This notice is being sent to inform you that Federal Warning Systems is conducting a voluntary customer satisfaction program that affects the UltraVoice siren control board, revision H9.

UV Controller Inspection

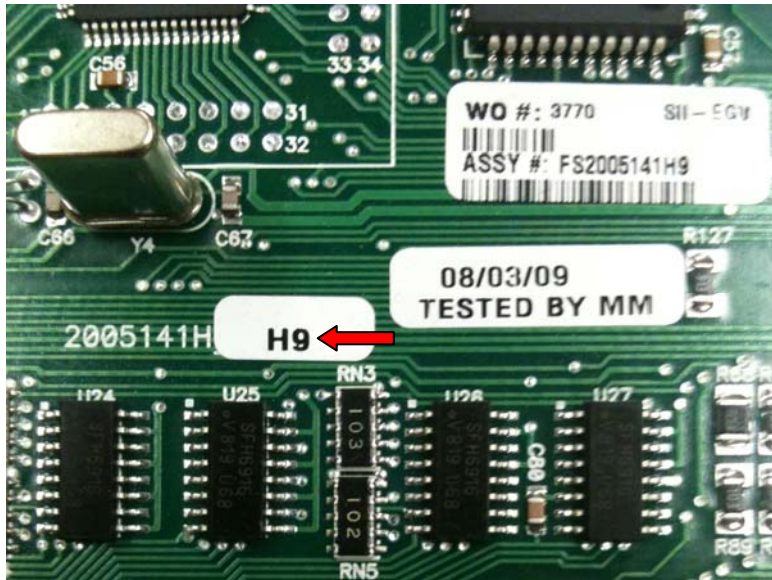
1. Holding the controller handle in the right hand side, look for the sticker on the board as per the picture below.

2. Determine if affected:
 - a. Only the revision H9 is affected. Look for the H9 sticker as shown in the picture.
 - b. Please note, that UltraVoice siren control board H8 and H10 revisions are not affected.

- c. Please note, that some of the earlier UltraVoice siren control boards will not have a sticker and are not the H9 revision.
 - d. If not the revision H9, then no action is required. Re-install the controller and hardware by reversing the instructions previously provided above.

- e. If revision H9, then place in static bag for transport.
 - f. Close the cabinet and ensure the hasp is secure. This is an extremely important step to prevent water damage.

- g. Lock the cabinets if applicable.
3. If it is the H9 revision, and has not already been modified, please contact our Customer Care Department at 800-548-7229, and request a RMA for the 2005141H9, in reference to service bulletin 56.
